CERTIFICATE OF JUMPING HILL CERTIFICAT DE CONFORMITE SCHANZENPROFILBESTÄTIGUNG

Place: Tauplitz / Bad Mitterndorf

Name: Kulm

HS = 225 m h/n 0,603

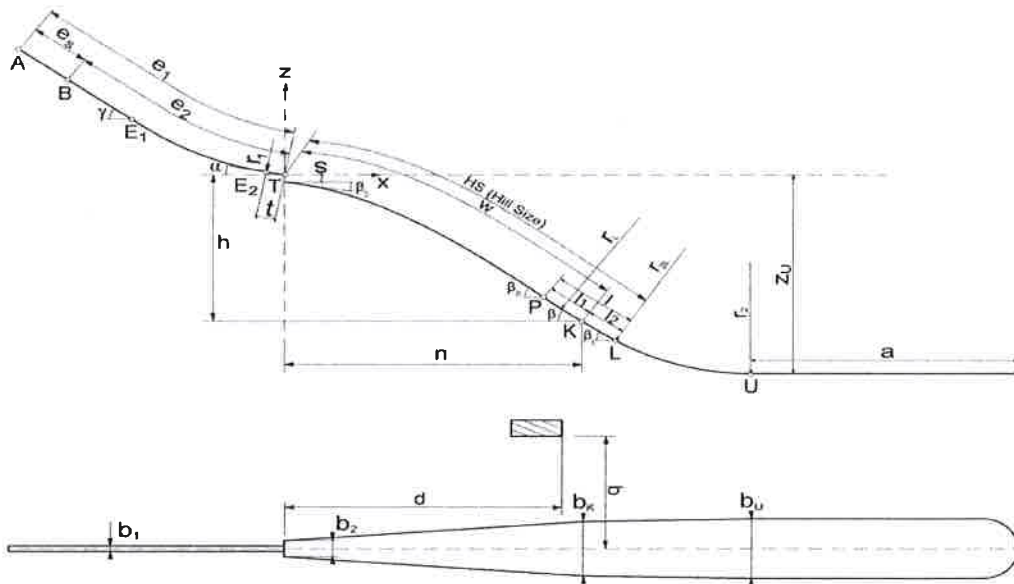
- inspection by Marko Mlakar (13th December 2014)
- remarks of inspection-report from 13th December 2014 must be observed.
- camera-podium in the perspective of jury and judges is not possible.
- inrun is not according to permission-designn - compare "e1"; "e2"; "es", it has to be improved with at least temporary solutions, especially starting area "es"
